# PLAN OF PROPOSED IMPROVEMENT

## ACACIA RIDGE PHASE 10

CITY PROJECT NO. 14833  
CONTRACT NO. 9340

Revision 2: 05/28/2024  
Sheet U-2: Changed pipe size P-1  
Sheet U-STM: Revised pipes P-1 and P-2,  
revised structures S-1 and S-2

ACACIA RIDGE PH 10	SHEET NO.
PROJECT NO. 14833	U-STM
STORM SEWER SCHEDULE	
CITY OF MADISON

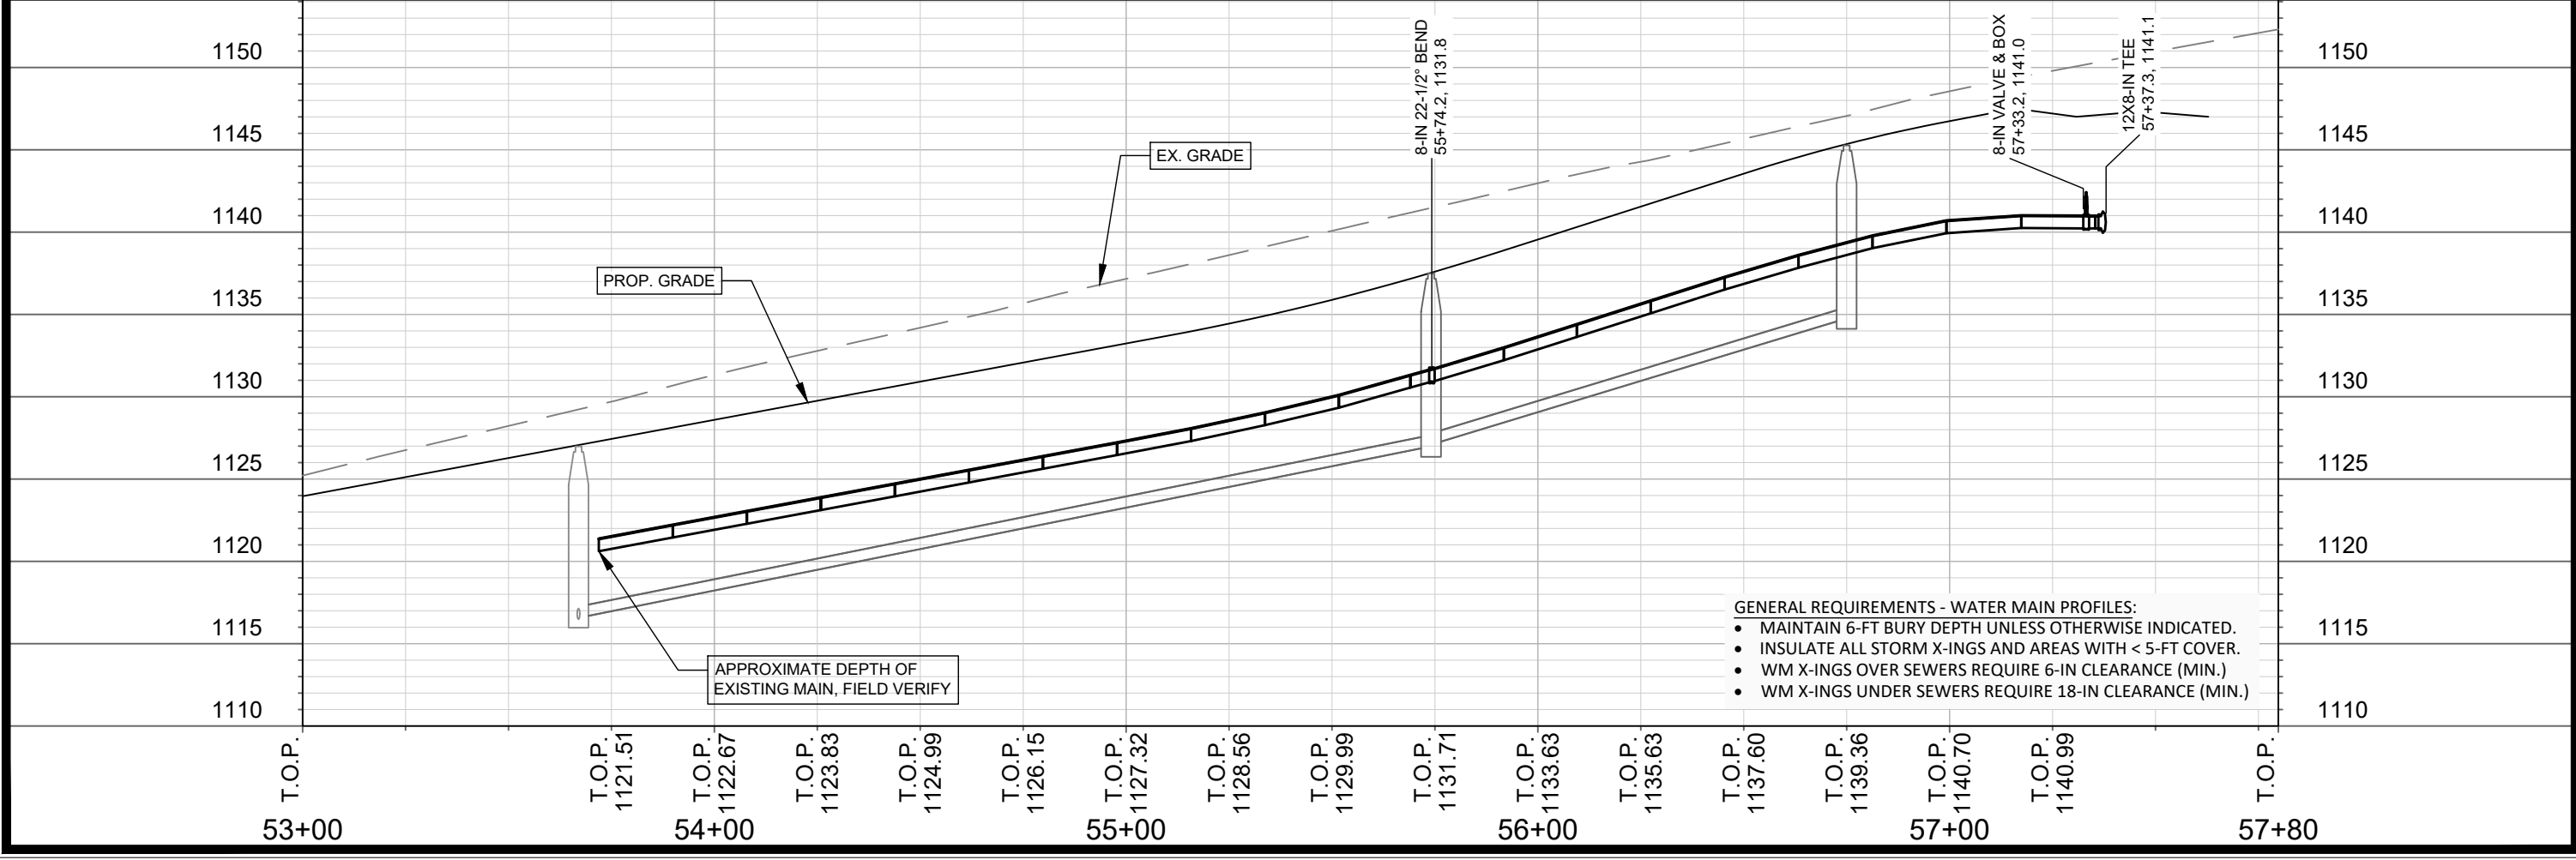
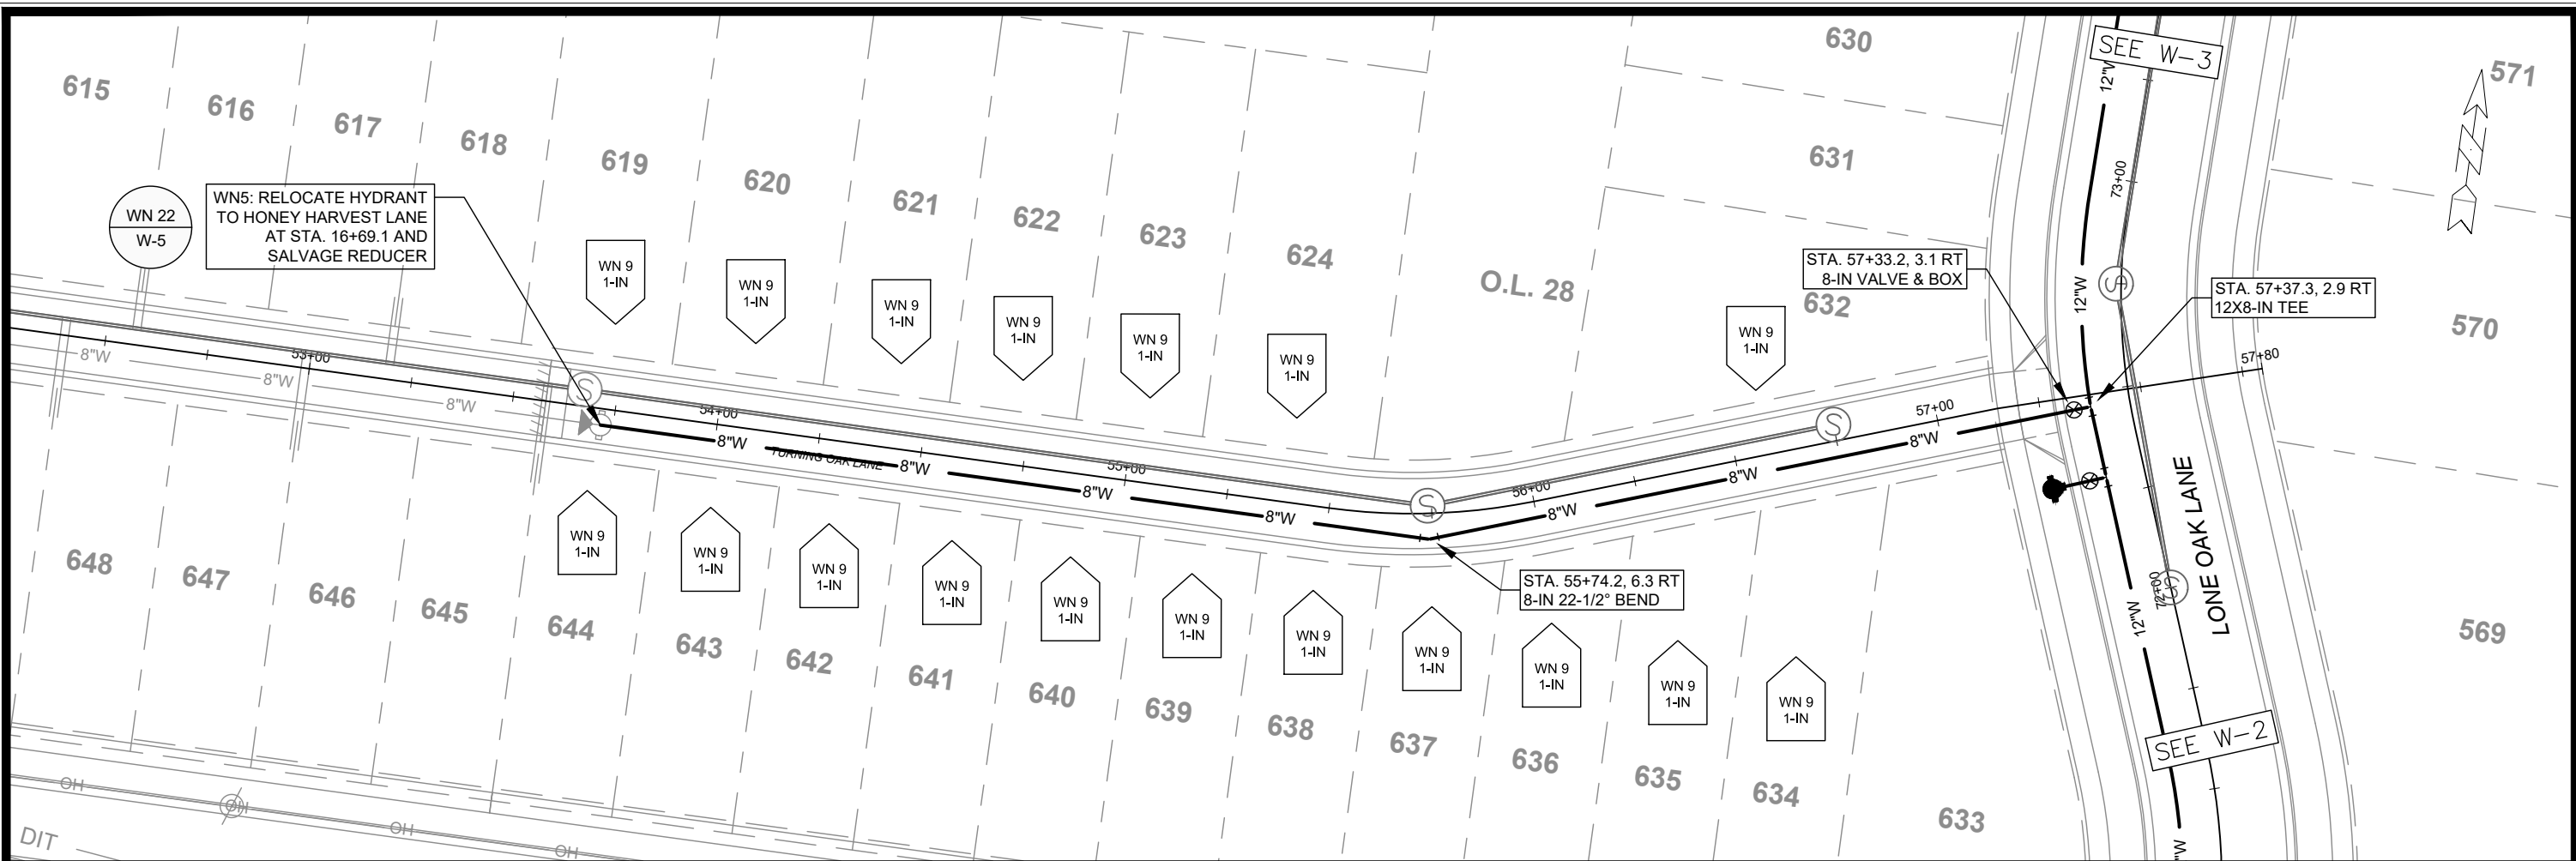
\* REVISED 5/17/2024 EEA

STRUC. NO.	STATION	LOCATION (OFFSET)	TYPE	TOP OF CASTING	E.I.	DEPTH	NOTES
<b>LONE OAK LN</b>							
* S-1	77+25.00	RT-17.50	15" RCP APRON END	-	1140.07	-	W/ GATE
* S-2	77+09.00	RT-17.50	H INLET	1144.55	1140.35	4.20	W/ R-3067-7004-V
S-3	75+44.33	RT-17.50	H INLET	1145.91	1142.11	3.80	LP; W/ R-3067-7004-VB
S-4	74+85.50	RT-17.50	H INLET	1146.21	1142.41	3.80	W/ R-3067-7004-V
S-5	74+68.50	LT-17.50	H INLET	1146.29	1142.69	3.60	W/ R-3067-7004-V

PIPE NO.	FROM (DNSTM)	TO (UPSTM)	DISCH. E.I.	INLET E.I.	PLAN (PAY) LGTH (FT)	PIPE LGTH (FT)	SLOPE (%)	PIPE SIZE	TYPE	NOTES
<b>LONE OAK LN</b>										
* P-1	S-1	S-2	1140.07	1140.35	16	15	1.87%	15"	TYPE II	-
* P-2	S-2	S-3	1140.60	1142.11	165	162	0.93%	12"	TYPE II	-
P-3	S-3	S-4	1142.11	1142.41	59	56	0.54%	12"	TYPE II	-
P-4	S-4	S-5	1142.41	1142.69	39	37	0.76%	12"	TYPE I	-
